Access Compliance Report

(Curb Ramps)

Intersection ID: 15175	Main Street: SOUTH_BV	Cross Street: POINDEXTER_DR	Location: SE
ADA ID: 637A5B442C11	Ramp Type: PerpDiag	Initial Pass/Fail: Fail	Overall Compliance: No
Codes/Mitigation Info/Possible Solution		Field Measurements/Component Compliance

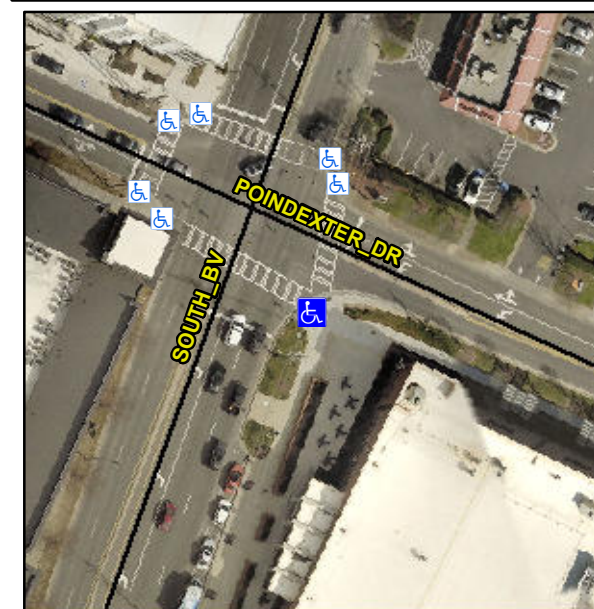
R304.2.2, R304.5.3

Compliance	Description	Data	Compliance	Description	Data
N/A	Ramp Length (in)	144.0	No	Ramp Slope (%)	8.4
Yes	Ramp Width (in)	137.0	No	Ramp XSlope (%)	4.2
N/A	Flare Type LT	N/A	N/A	Flare Type RT	N/A
N/A	Flare Slope LT (%)	N/A	N/A	Flare Slope RT (%)	N/A
N/A	Flare Traversable LT?	N/A	N/A	Flare Traversable RT?	N/A
N/A	Landing Length (in)	N/A	N/A	DWS Provided?	N/A
N/A	Landing Width (in)	N/A	N/A	DWS Contrast?	N/A
N/A	Landing Slope (%)	N/A	N/A	DWS Length (in)	N/A
N/A	Landing X Slope (%)	N/A	N/A	DWS Full Width?	N/A
N/A	Landing Curb? (Y/N)	N/A	N/A	DWS Offset (in)	N/A
N/A	Shared Landing?	N/A			
N/A	Gutter Ponding?	N/A	N/A	Gutter Slope (%)	N/A
N/A	Gutter Lip Ht (in)	N/A	N/A	Gutter X Slope (%)	N/A
N/A	Painted X Walk1?	Yes	N/A	Painted X Walk2?	Yes
	X Walk 1 Direction	To NE		X Walk 2 Direction	To NW
N/A	X Walk 1 Width (in)	114.0	N/A	X Walk 2 Width (in)	114.0
	X Walk 1 Slope (%)	4.0		X Walk 2 Slope (%)	5.0
	X Walk 1 X Slope (%)	5.0		X Walk 2 X Slope (%)	1.0

Remove & Replace Curb Ramp With Two New Directional Ramps or Equivalent.
